**HMC ARCHITECTS
3546 Concourses Street
Ontario, California 91764**

Arvin High School ESSER III Phase 1 Roofing

Kern High School District

File No: 15-H3 A#03-122508

A10.41 Roof Details

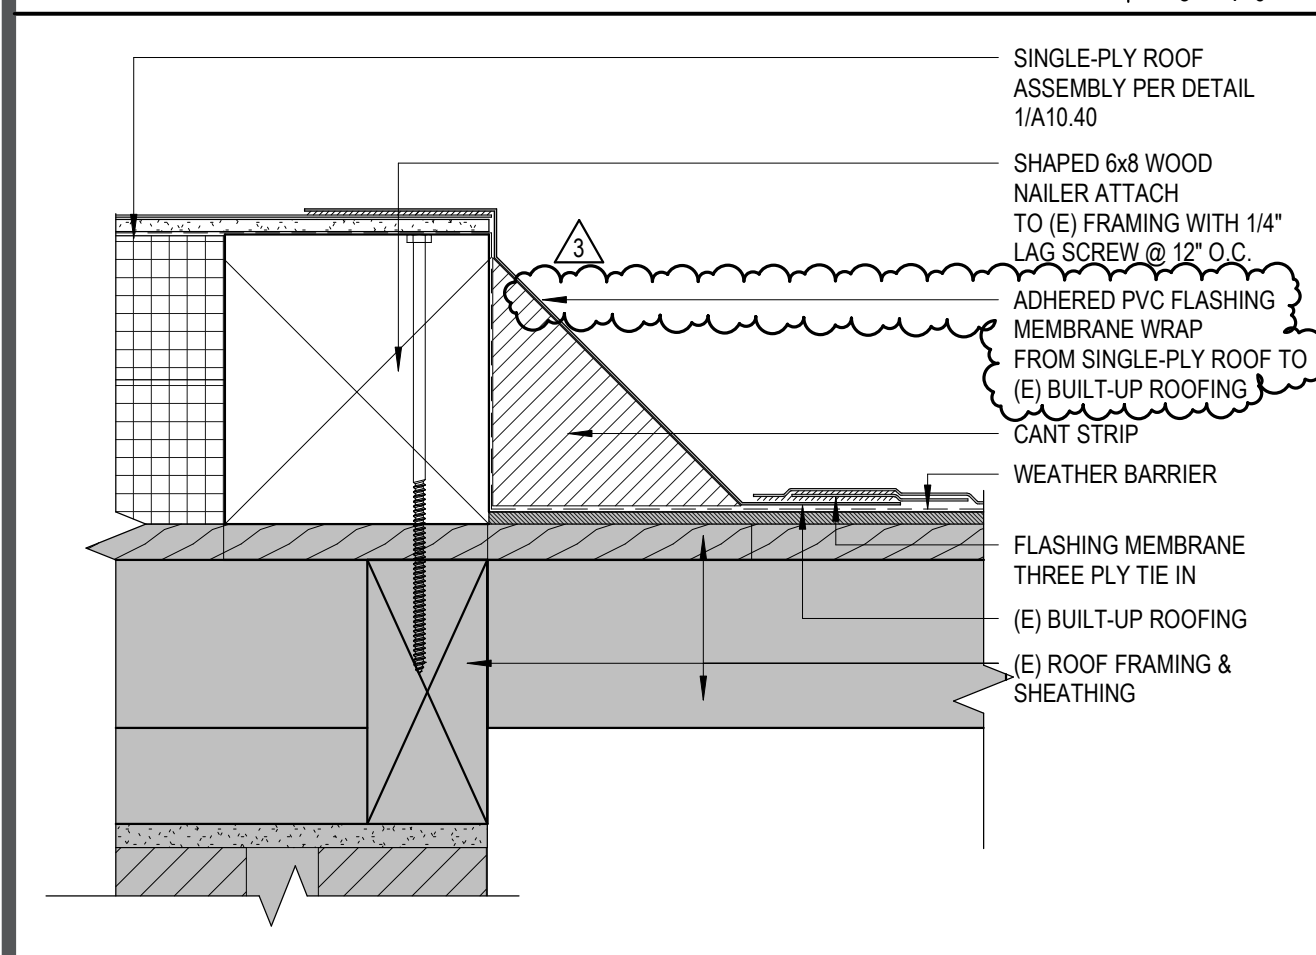
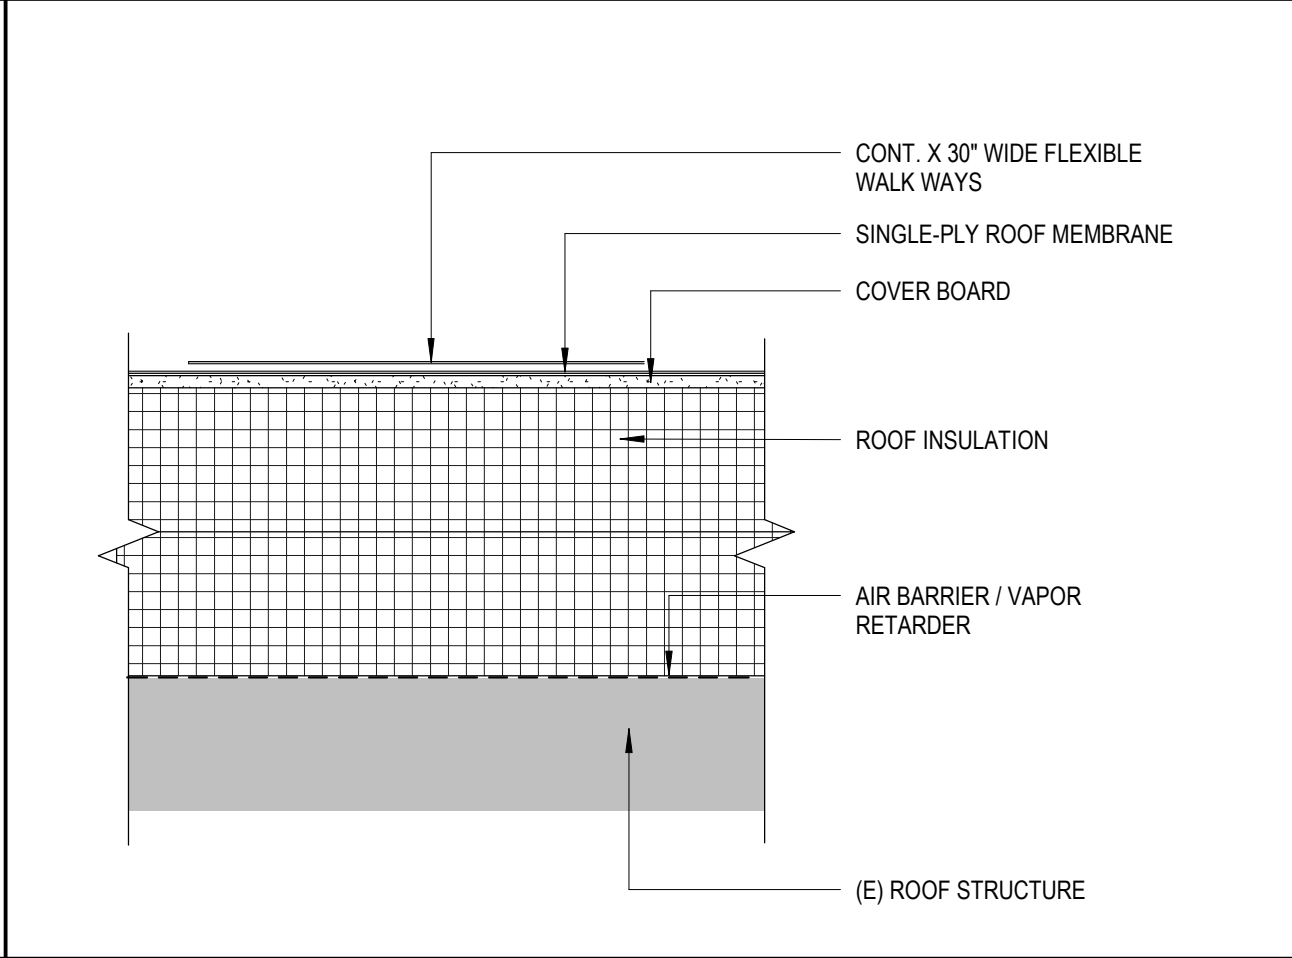
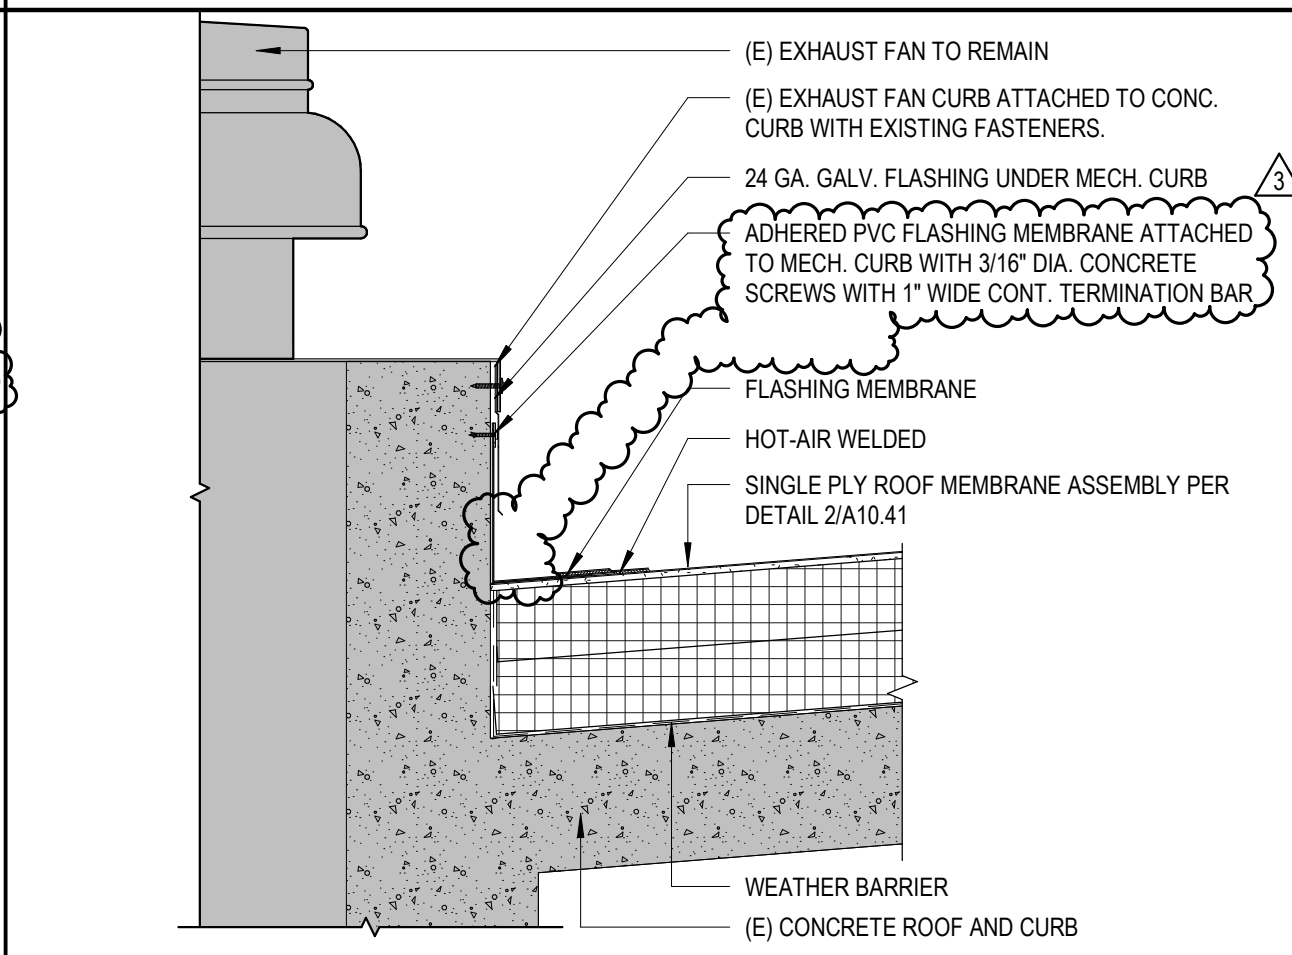
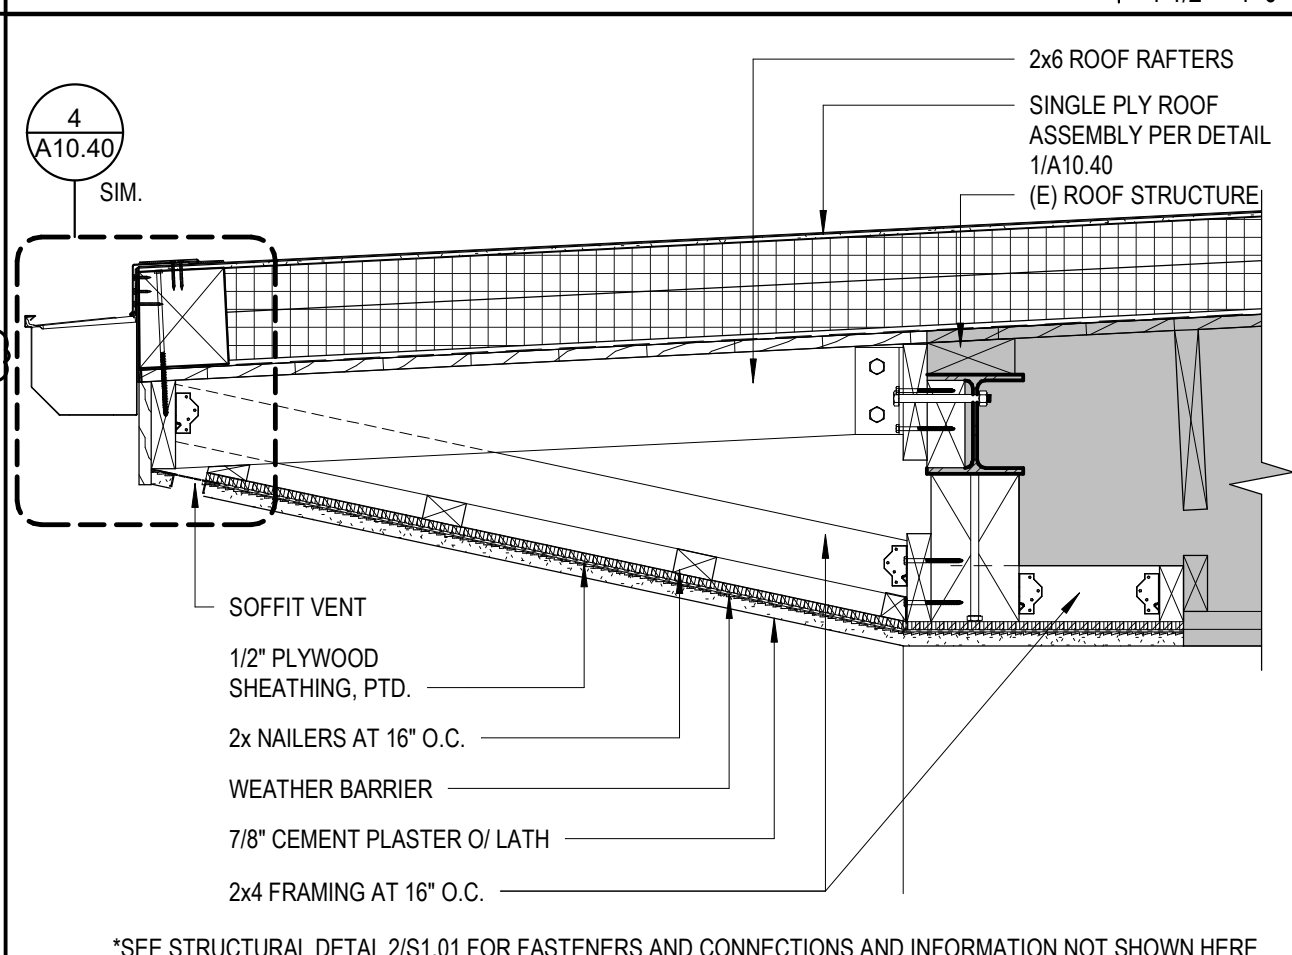
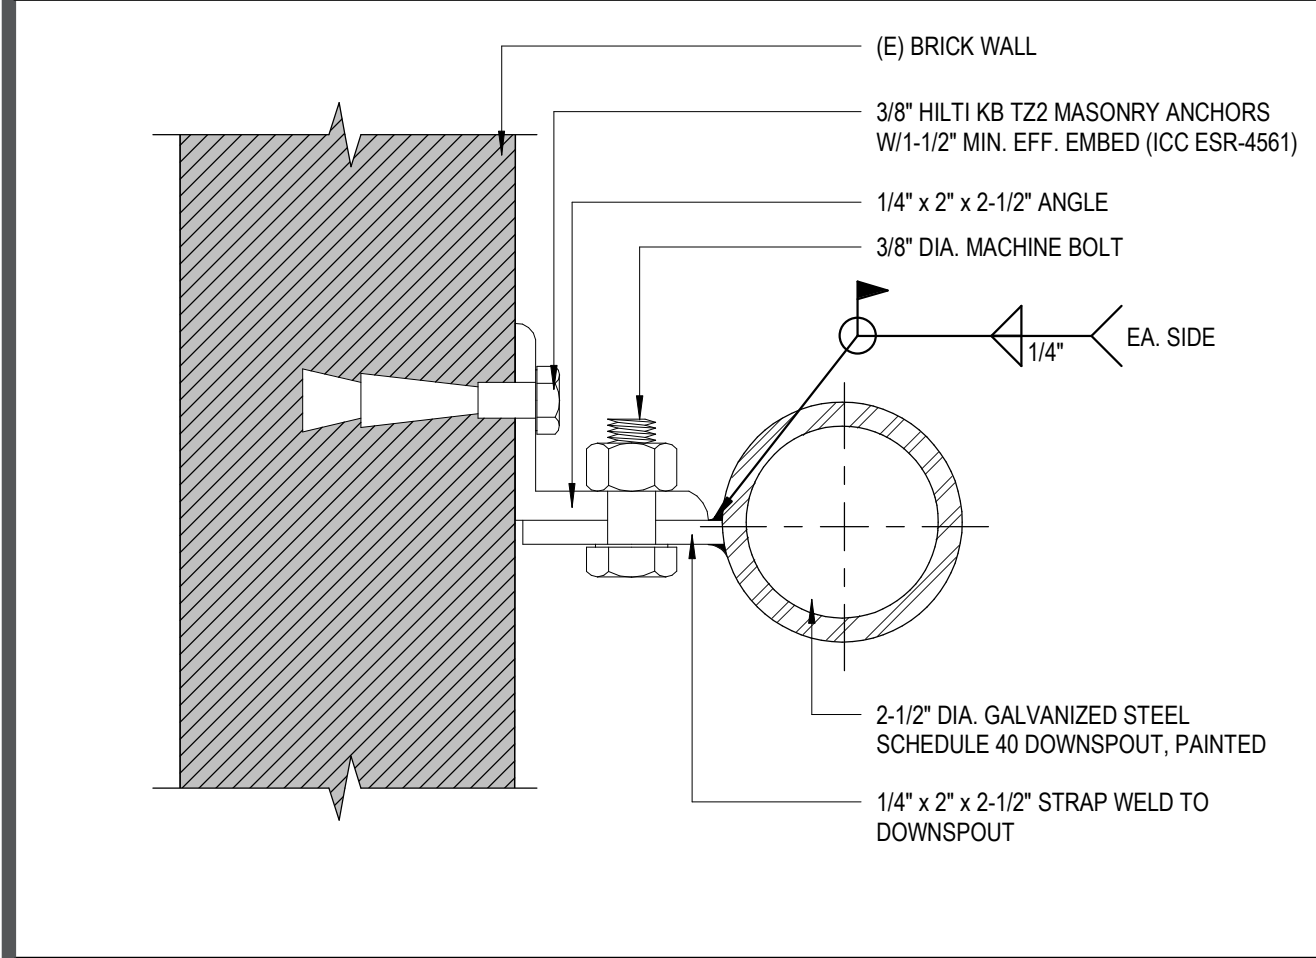
- 1.) DELETE cant strip as shown and clouded per Delta 3.
- 2.) MODIFY PVC Coated metal flashing to Adhered PVC Flashing Membrane on Detail 2, 17, 18, 21 and 22/A10.41 as shown and clouded per Delta 3.
